Consultation Response from: KC Environmental Health (Pollution & Noise Control)
2026/90460 - Land off, Hermitage Park, Lepton

Discharge of details reserved by conditions 27 (BEMP), 31 (Noise), 32 (Travel Plan), 39 (Cycle Storage) on previous permission 2025/90105 for variation of conditions 6 (PROW), 9 (boundary treatment), 38 (bin collection), 40 (car parking), 41 (access) on previous outline permission 2022/91735 (with access and layout) for the erection of 80 dwellings and associated work

Date Responded:
Monday, 30 March 2026
Responding Officer:
Hannah Kent
Responding Ref:
WK/202605579

Figure E: Noise Exposure Per Building Façade – Ground Floor Day

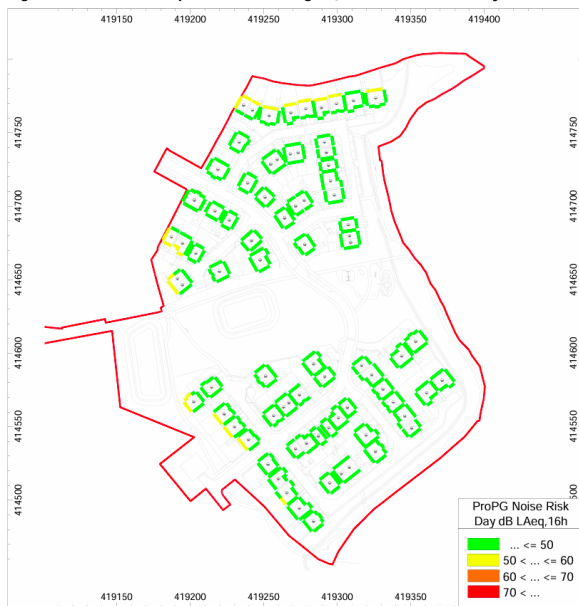
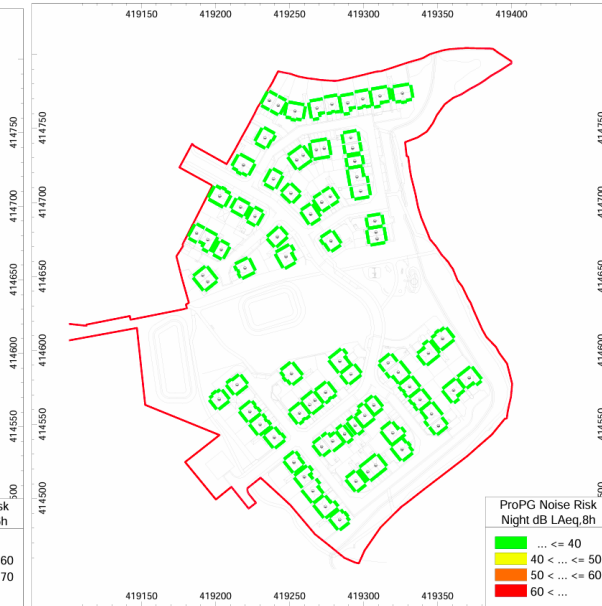
The results of the initial assessment are presented (above), and the report states:

The development has been considered to fall within ‘low risk’ noise levels, where ProPG notes that:

The submitted report satisfies the requirements of condition 31, and confirms as detailed above, that a standard scheme of façade insulation for habitable living rooms and bedrooms is suitable and that no additional provisions for overheating ventilation is necessary, such that partially or fully open bedroom windows would remain acceptable at night.

The submitted report satisfies the requirements of condition 31 which may now be discharged.
